# Draft Amendment C293yara to the Yarra Planning Scheme

## Officers responses to commonly raised issues in submissions

Figure 1: 10AM Shadow comparison for Oxford Street Reserve

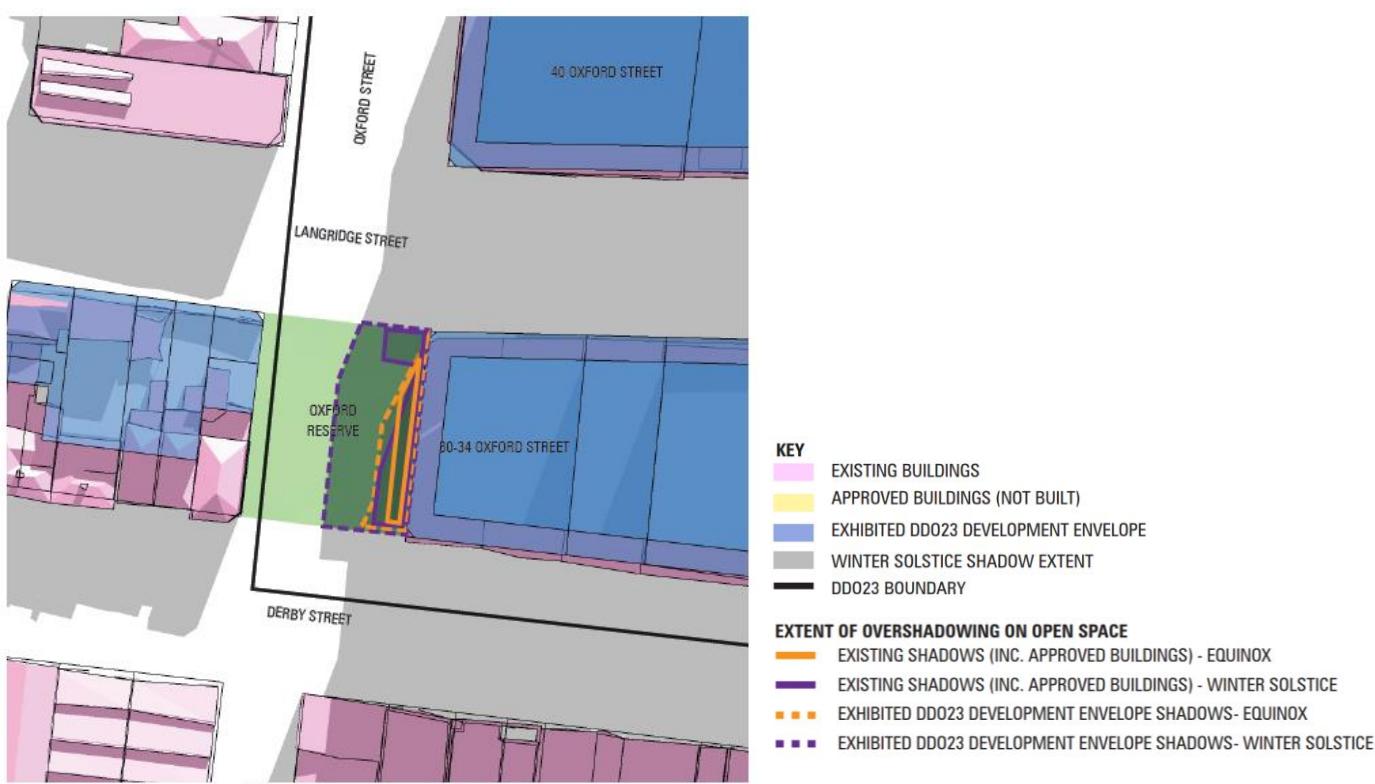
Overshadowing of public open space from the existing conditions in Collingwood South is very significant at the winter solstice, particularly between 10-11AM (see Figure 1, solid purple line). The analysis demonstrated that additional overshadowing from potential form of DDO23 is minimal at 10AM (dashed purple line), as it is the existing buildings overshadow most of the park already. Minimising the relatively small amount of additional overshadowing caused by the potential form of DDO23 would mean to make significant changes to parts of DDO23, including to confine new development to the existing built form.

Due to overshadowing analysis with regards to Oxford Street Reserve, the street wall adjoining the north eastern boundary of the reserve is proposed to be lowered to 11m (also see response to Overshadowing of Public Open Space).
